# **Intel<sup>®</sup> Mobile Pentium<sup>®</sup> II Processor Specification Update**

Release Date: July 2000

Order Number: 243887-022

New Mobile Pentium® II Processor in Mini-Cartridge Package Label with Supplier Matrix Mark Removed

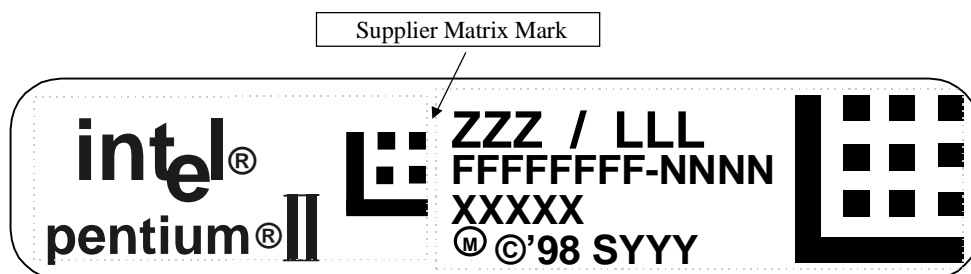
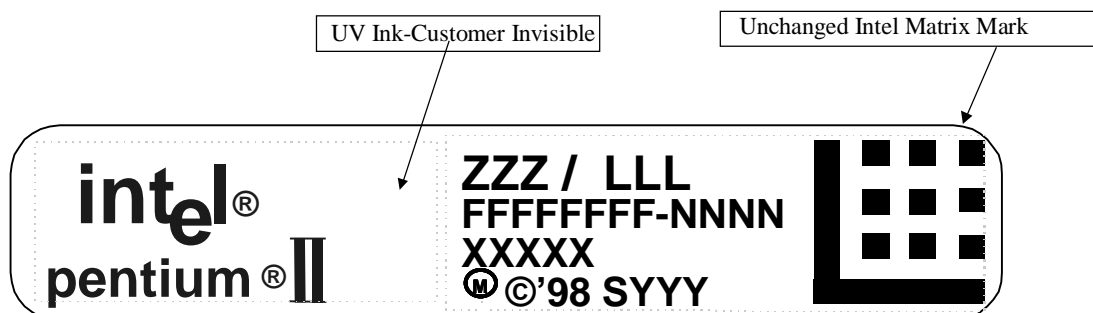
Old Mobile Pentium® II Processor in Mini-Cartridge Package Label with Supplier Matrix Mark

**Figure 2. Workaround Flowchart: SMBALERT#-Driven System**

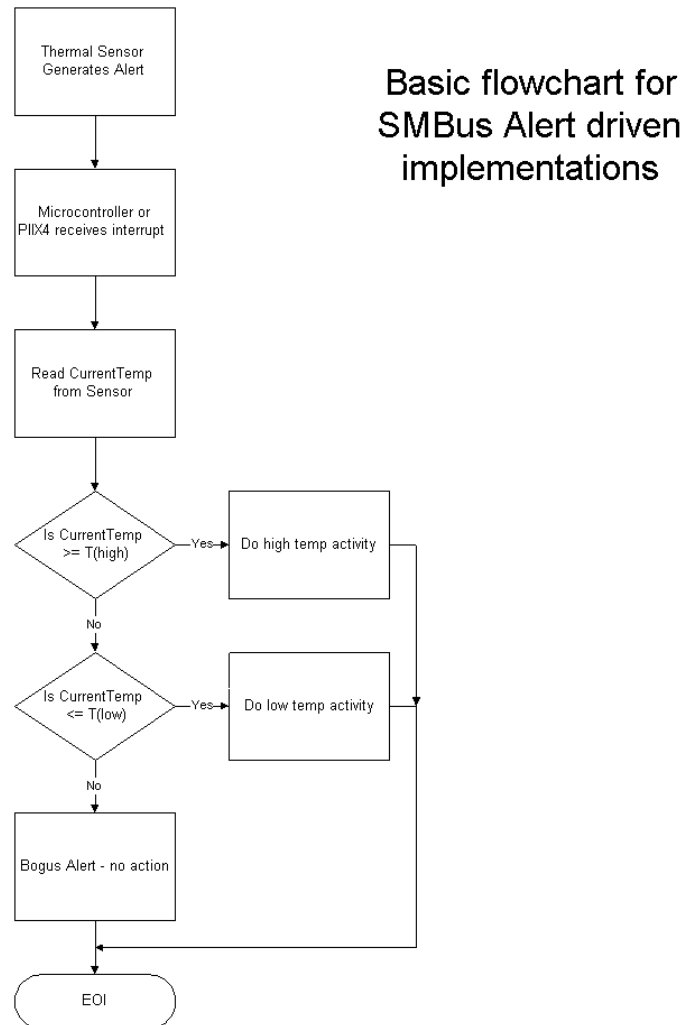
Under the conditions described below, the thermal sensor incorrectly generates the SMBALERT# interrupt. All of the following conditions must be met to trigger a false interrupt:

1. Before servicing an interrupt from the thermal sensor, read and compare the processor thermal reading with the threshold limits ( $T_{HIGH}$  or  $T_{LOW}$ ). Figures 2 and 3 provide basic flowcharts for the implementation of this workaround in an interrupt driven system.
2. If the firmware implemented polls the Status Register only, then before taking any action, re-read the temperature register and do a comparison with the alarm threshold limits ( $T_{HIGH}$  or  $T_{LOW}$ ) to determine if the value is actually still within the temperature window.

**Figure 3. Workaround Flowchart: SMI#-Driven System**

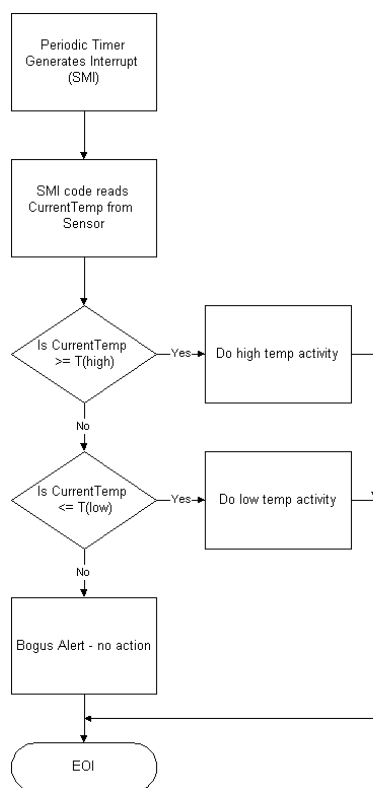
3. Use a temperature polling scheme to monitor the processor temperature.

**Figure 5.6. Cross Sectional View with Vertical Dimensions**

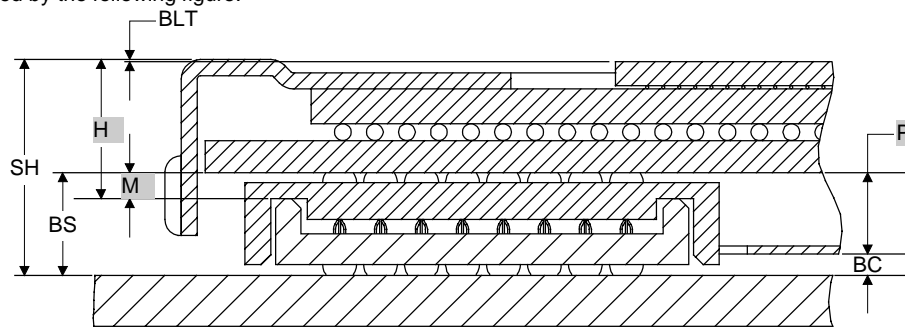
### B1. Misabeled Vertical Dimension Parameters

Figure 5.6 in the *Mobile Pentium® II Processor at 233 MHz, 266 MHz, and 300 MHz* datasheet should be replaced by the following figure:

**Figure 5.3. Surface-Mount BGA1 Package—Top and Side View**

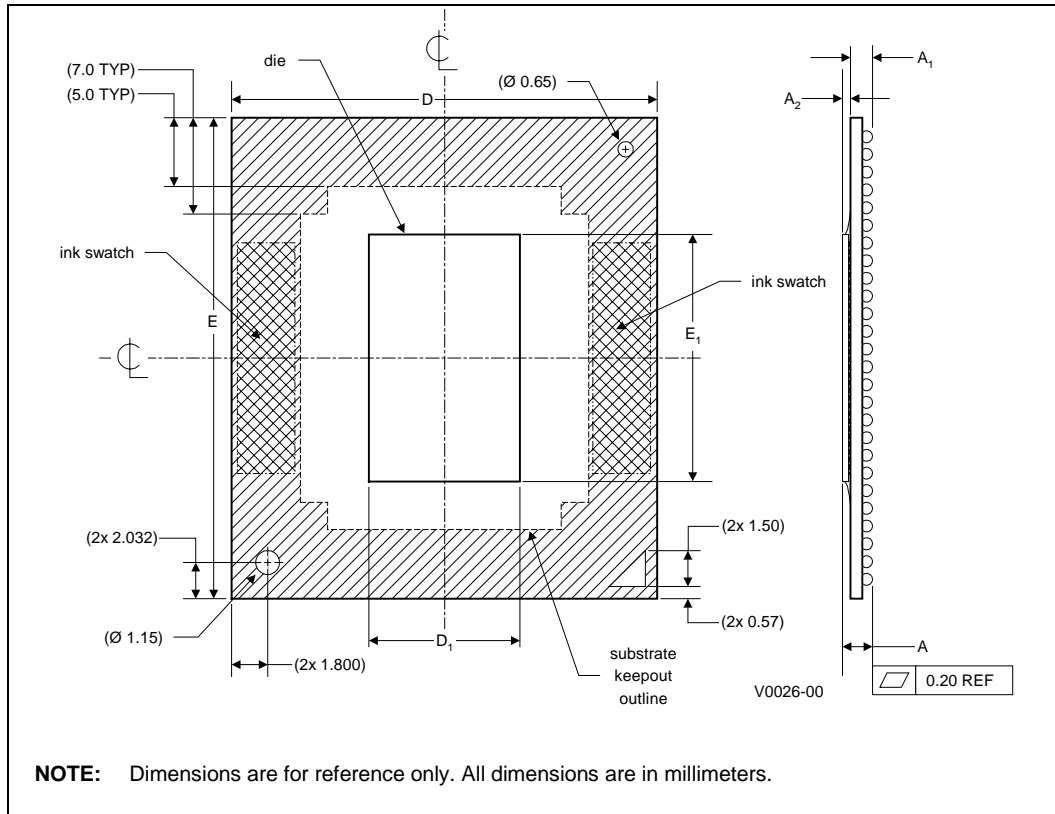
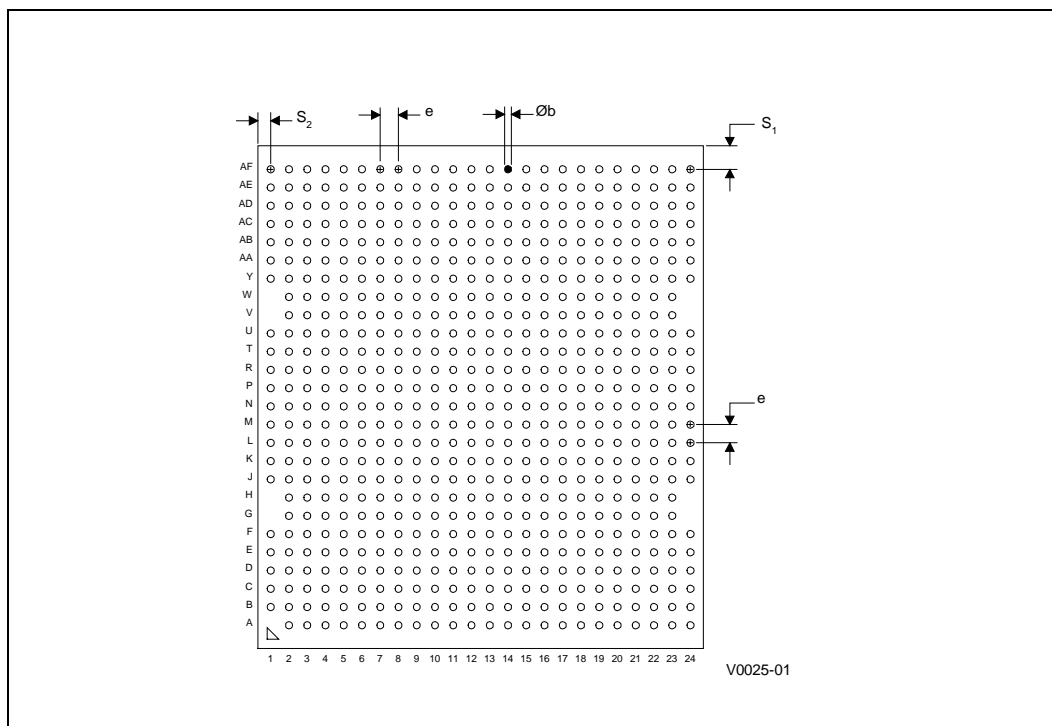
The following table and figures show the updated mechanical specifications for the BGA1 package, listed as Table 5.2, Figure 5.3 and Figure 5.4, respectively, in the *Mobile Pentium® II Processor in BGA Package at 366 MHz, 333 MHz, 300PE MHz, and 266PE MHz* datasheet.

**Figure 3.3 Generic Clock Waveform**

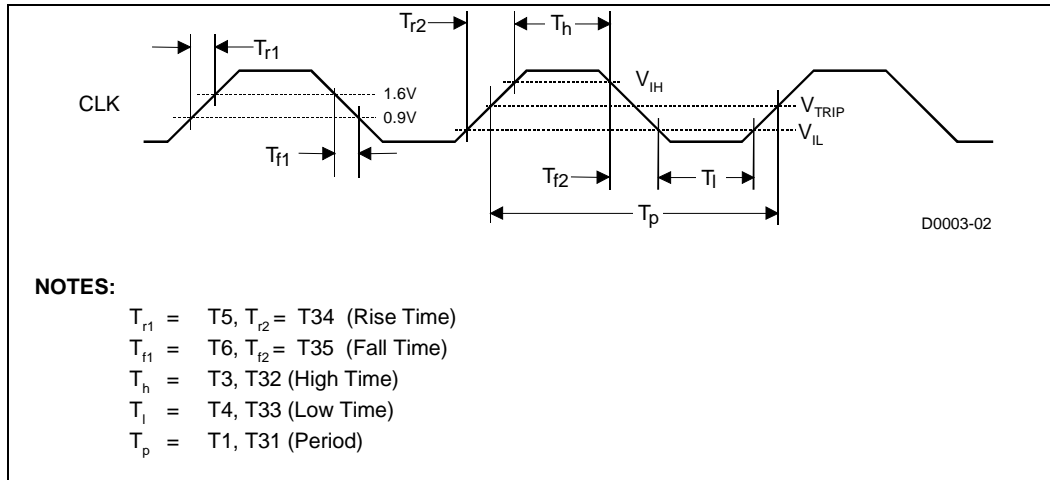
### ***B14. Generic Clock Waveform Figure***

Figure 3.3 in *Mobile Pentium® II Processor in Mini-Cartridge Package at 366 MHz, 333 MHz, 300PE MHz, and 266PE MHz* datasheet (Order Number 245108), and the *Mobile Pentium® II Processor in BGA Package at 366 MHz, 333 MHz, 300PE MHz, and 266PE MHz* datasheet (Order Number 245106) has been updated. The following figure is to replace the ones in the above documents.

Figure 1. TAP Gageable Thread Clarification

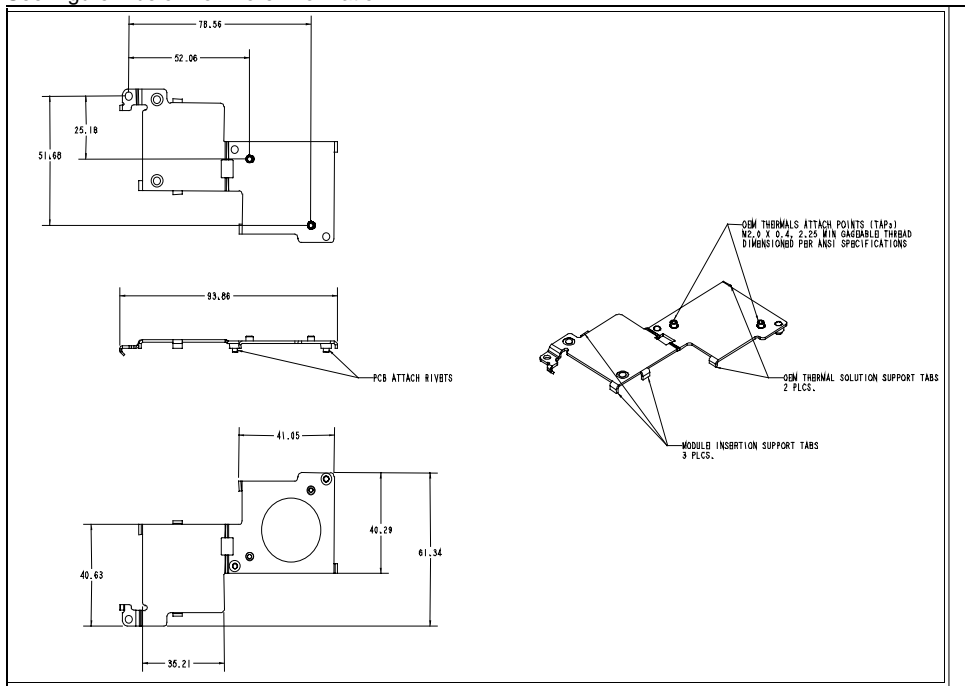
In the *Intel® Pentium® II Processor Mobile Module : Mobile Module Connector 1 (MMC-1)* and the *Intel® Pentium® II Processor Mobile Module : Mobile Module Connector 2 (MMC-2)* datasheets (Order Numbers 243667 and 243668, respectively), the thermal attach point (TAP) gageable thread specification was not clearly identified in Figure 14, of Section 5.2. The following is the TAP clarification:

OEM Thermal Attach Points (TAPs) M2.0 x 0.4, 2.25 min gageable thread dimensioned per ANSI specification.

See Figure 1 below for more information.
